Application No: DA 2022/76
Council reference: SP: CF 2920337 & 9296310
Land: Corner of Minna Road and Bass Highway (18 and 20 Minna Road),
Heybridge and 22 Minna Road, Heybridge, Tasmania
Proposal: Heybridge Converter Station, Marinus Link

Response to Requests for Additional Information dated 28 November 2024

Proposal: Heybridge converter station

FIGURE 1

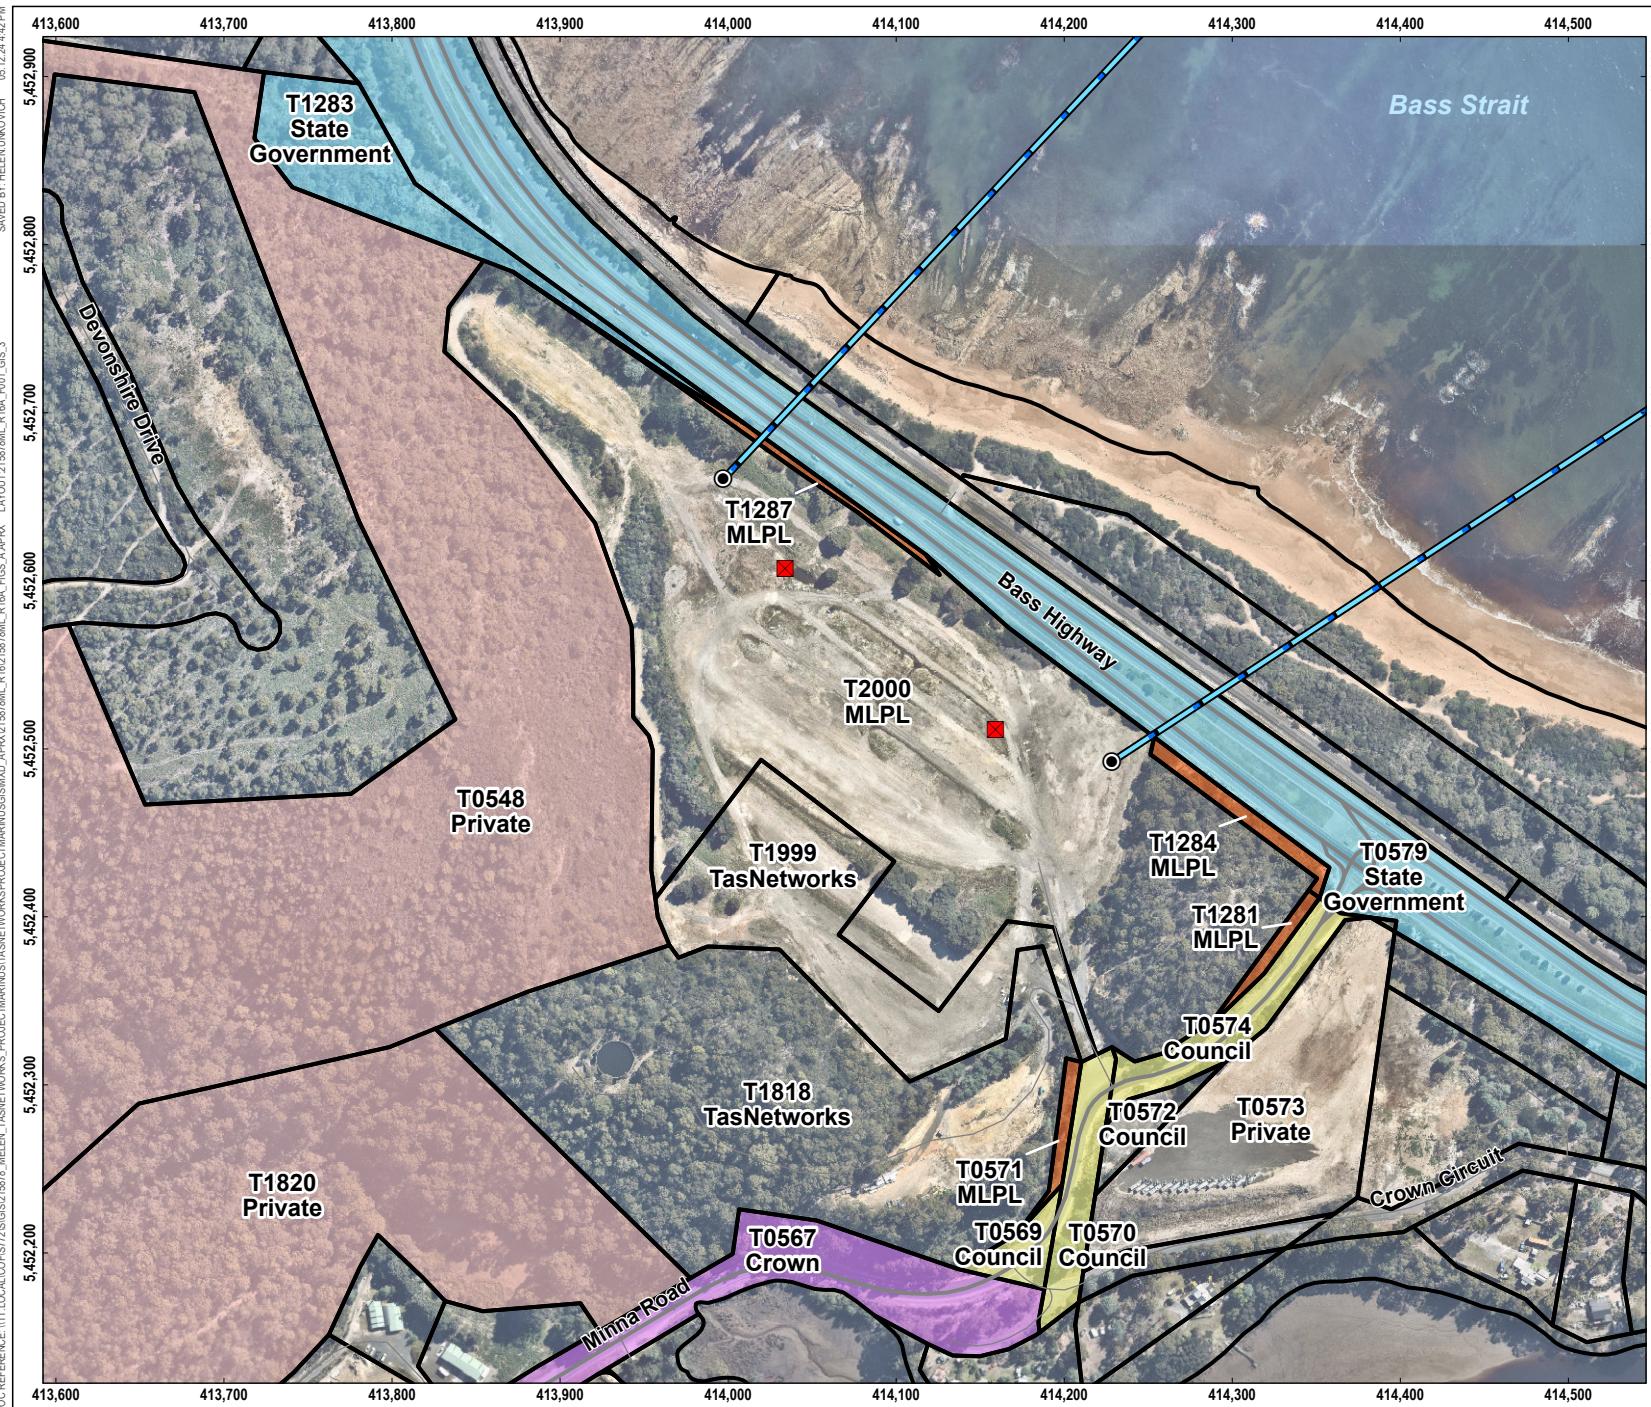
Council RFI	Response to RFI
<p>Adjoining is defined within the TPS 'means next to, or having a common boundary with'. Further, the photo montages do not show the proposed built form when viewed from the adjoining properties.</p> <p>It is noted that the spelling of Bass Strait is incorrect throughout this Assessment and page 37 has two bookmark errors.</p> <p>Further information is required to evidence achievement of clause 20.4.1, P1.</p>

Therefore the ‘adjoining properties’ as per Performance Criteria 1 of Clause 20.4.1 are the 12 properties which directly adjoin the subject site.

An assessment of each of the properties adjoining the subject site confirms that the proposed building height would not cause unreasonable impact to those properties given their uses, vegetated nature, natural screening and buffers and their limited visibility of the subject site and sensitivity (limited sensitive receptors). It is for these reasons that photomontages are not warranted from adjoining properties.
